Subject: Second Geologic Review  
6472 and 6498 South Bybee Drive  
Weber County Parcel Numbers: 07-753-0001 and 07-753-0002  
Uintah, Weber County, Utah  
SA Project No: 15-140

Report: "Memorandum - Review Response for Geological Review - 6472 and 6498 South Bybee Drive, Weber County Parcel Numbers: 07-753-0001 and 07-753-0002 Uintah, Utah, SBI Project Number 2-14-522," dated April 24, 2015, prepared by GeoStrata, 14425 South Center Point Way, Bluffdale, Utah 84065, prepared for Matt Rasmussen

Geologic Submittal Status: **INCOMPLETE**

**Plate  
A-3**

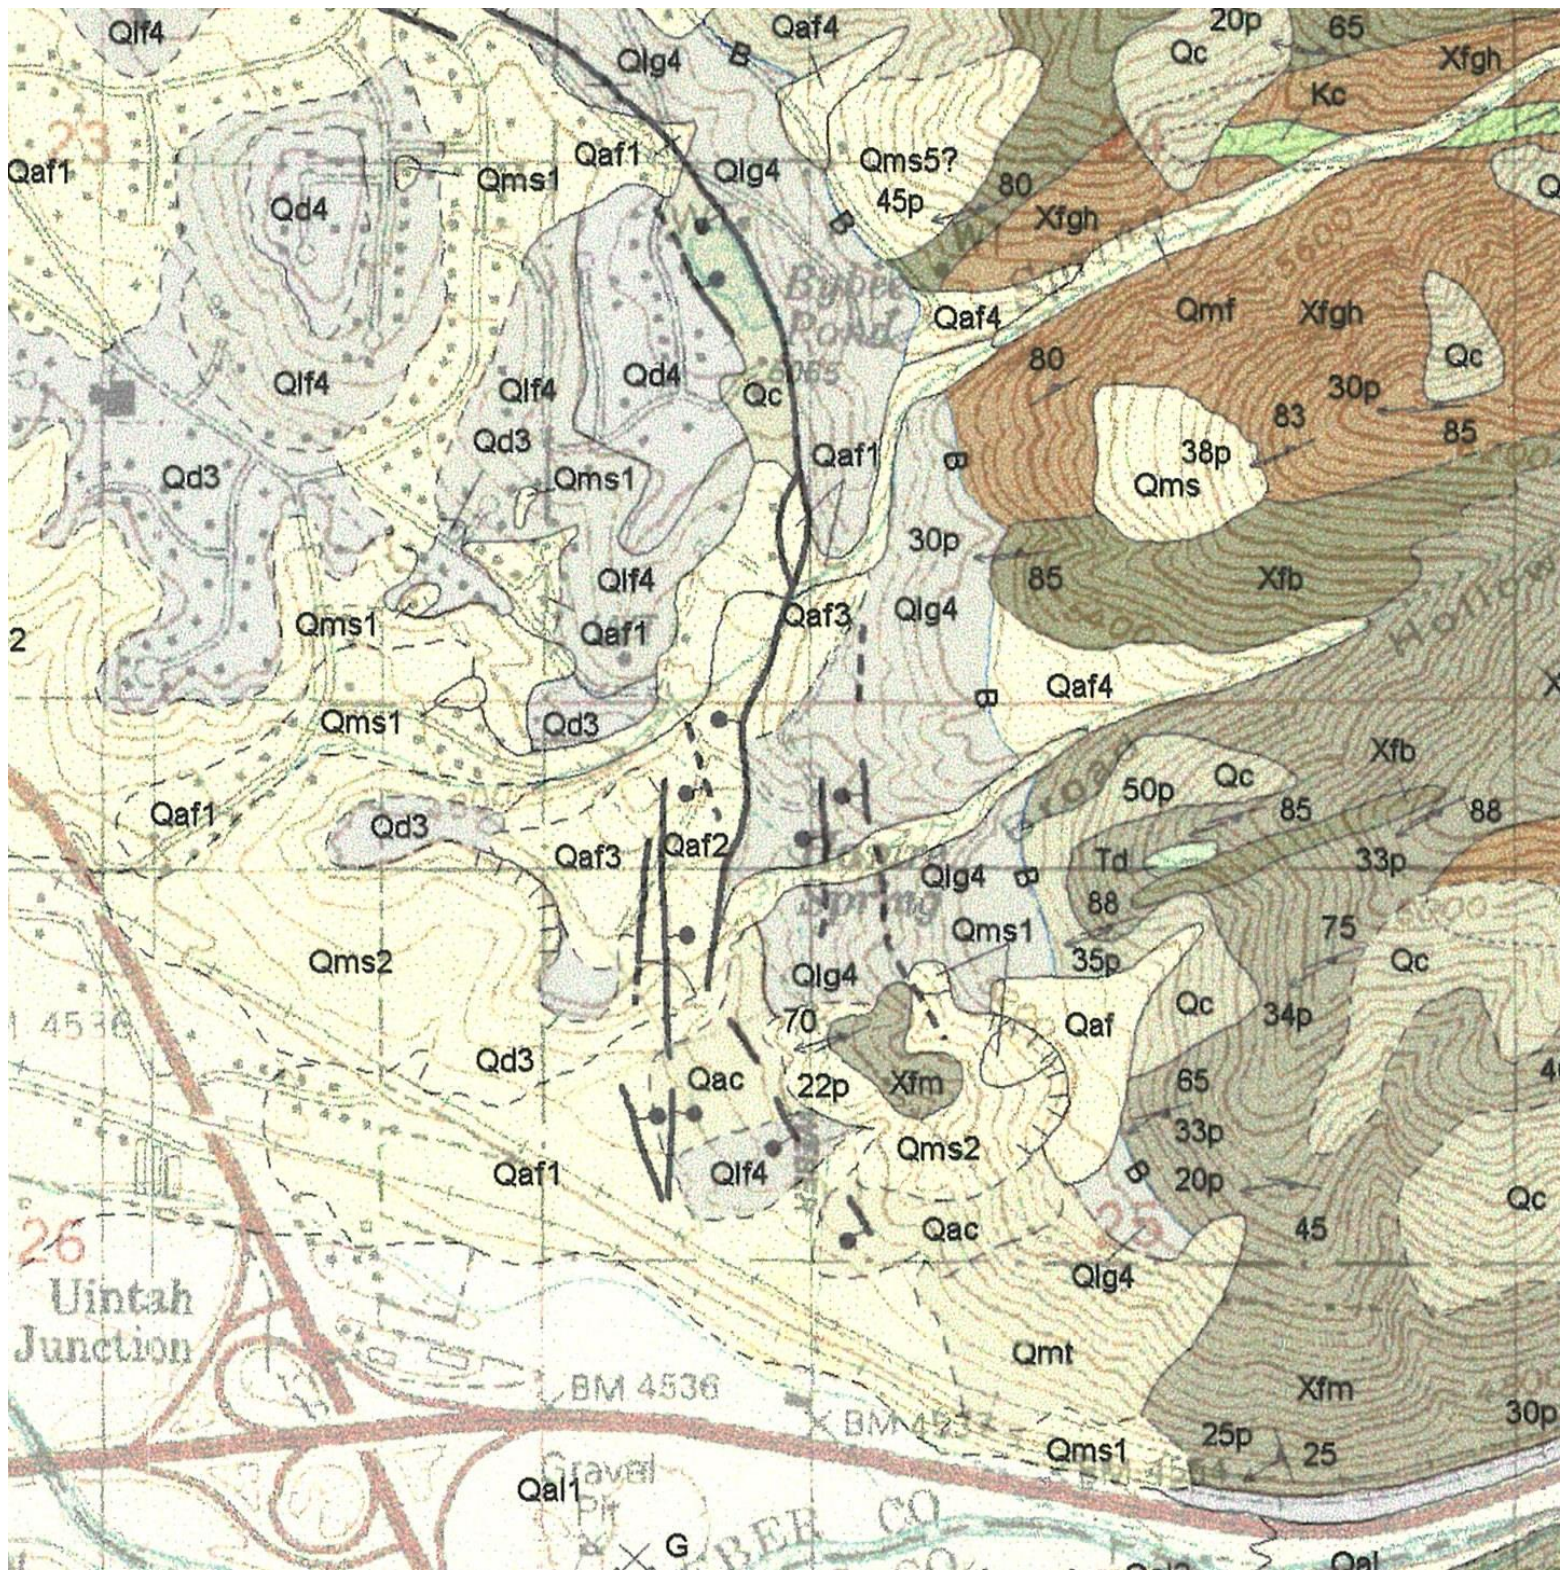
SBI noted that the Utah Geological Survey geologic map referenced in the April 24, 2015, GeoStrata memorandum (Yonkee and Lowe, 2004), had two apparent errors and attached a corrected version, provided by Mr. Jon King of the UGS. Apparently the corrected version was not distributed, and is attached herein for completeness. No recommendations.
